**Subject:** Nuclear Industry Comments on the Technical Basis for New Performance-Based  
Emergency Core Cooling System Requirements

**Project Number: 689**

**Comments on the Adequacy of Technical Information in  
RIL-0801 and NUREG/CR-6967 Requested in Federal Register Notice**

**Figure 1. Comparison of ANL & CEA Post-Oxidation Ductility Offset Strain vs. CP-ECR. Samples were oxidized at 1200°C and have a hydrogen content of approximately 600 wppm.**

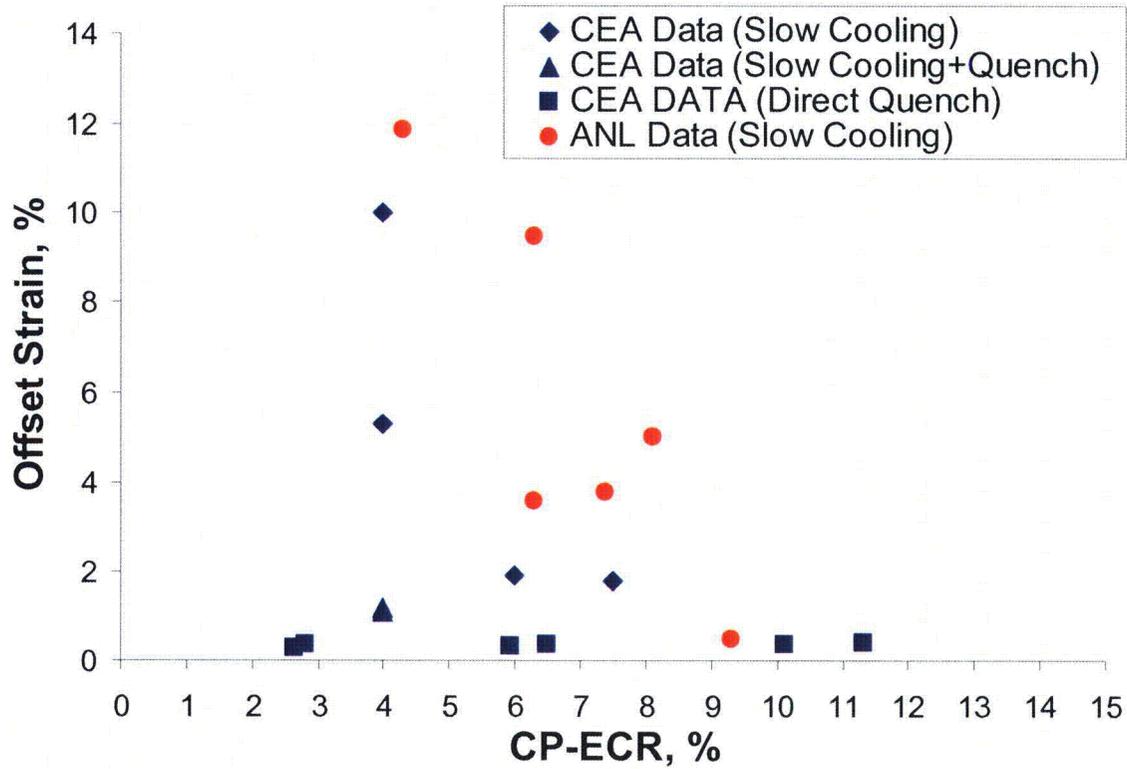
The ANL program combines separate effects tests and integral tests to evaluate the impact of burnup on fuel rod behavior during a LOCA. However, many of the ANL observations on prehydrided and irradiated samples are not consistent with results obtained at overseas facilities such as CEA/EDF/Framatome (France). Figure 1 highlights some of the differences in the ductility data for samples with a hydrogen content of approximately 600 wppm that have been oxidized at 1200°C.

There are lab-to-lab differences in the sample preparation that can contribute to differences in ductility measurements. First, there is no "typical" LOCA temperature history applied by all experimentalists during the sample oxidation process. The temperature history used to oxidize and cool the samples plays a key role in the eventual sample ductility. ANL has a fast initial ramp followed by a slow approach to the final oxidation temperature to avoid a temperature overshoot. CEA has a direct ramp to temperature without overshoot. The ANL heating method is presented in Figure 2 and results in less total oxidation at target temperature (i.e. 1204°C). The CP-predicted ECR values have been placed on Figure 2 temperature history in order to demonstrate the effect on ECR accumulation associated with the non-isothermal oxidation process used by ANL. (The ANL samples accumulate ~5% ECR before even reaching the target limiting temperature. Actual LOCA scenarios would accumulate even more ECR before approaching the temperature acceptance criterion.)

Second, the cooldown from oxidation temperature also contributes to the sample ductility. ANL furnace cools most of their samples compared to the CEA tests that are mostly quenched directly from the oxidation temperature. The direct quench study is of scientific value as it is useful in developing an overall understanding of the material behavior during cooling but it does not represent a realistic LOCA scenario. A third effect is the temperature at which quench occurs. The heating rate, cooling rate, and quench temperature all have an impact on the prior-beta and hydride morphology in the beta phase.

**Figure 4. GE-14 Fuel Design Calculated PCT Response to a typical LOCA Event with and without Crud**

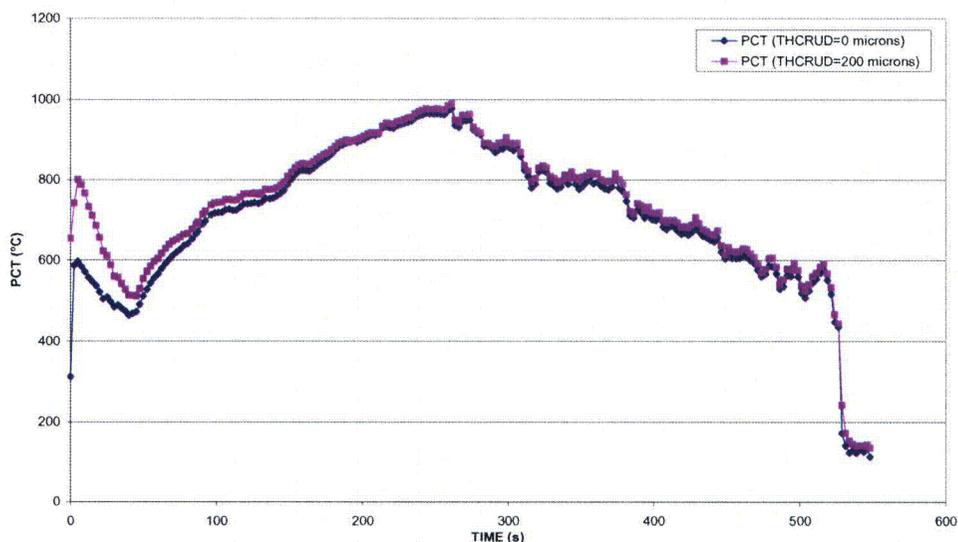
An example of a BWR analysis that demonstrates the potential effect of crud is presented in Figure 4. This analysis compares the PCT response of a typical fuel rod during a normal LOCA transient to the same fuel rod with the addition of crud. A conservative value for the thermal conductivity of the crud is assumed in the analysis. The analysis demonstrates that the principal result of the crud addition is to increase the initial calculated PCT and early peak temperature. Once the initial stored energy is mitigated, crud no longer has a great effect on PCT. This behavior is also typical of PWR fuel rod response.
